Product Change Notification

108030 – 00

Change Notification #: 108030 - 00
Change Title: Quad Core Intel® Xeon® 7300 Series & Dual Core Intel® Xeon® 7200 Series, PCN 108030-00, Product Material, Qualification of 38.5mm IHS lids
Date of Publication: October 29, 2007

Key Characteristics of the Change:

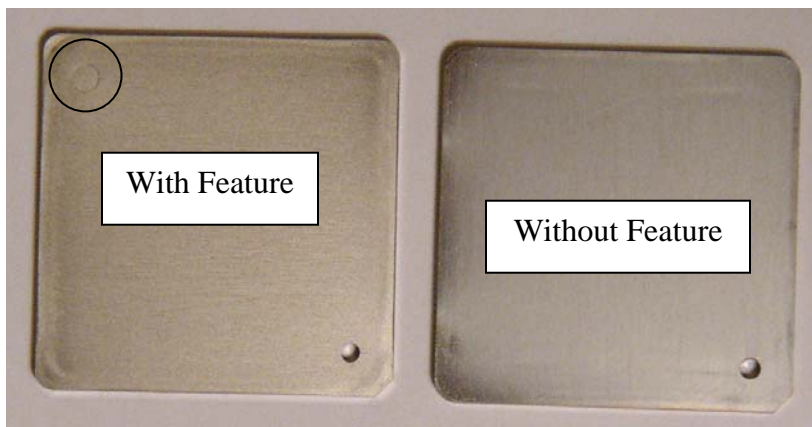
The products identified on this notification will be shipping on a new IHS lid without a visible top indentation in addition to the existing IHS lid with the top indentation. Feature is 3.0mm in diameter, 0.005mm to 0.1mm in depth.

This new feature has no expected significant impact on performance, quality, reliability, functionality, interchangeability, handling, or manufacturability of the product. It is used for Intel internal process differentiation and should be ignored.
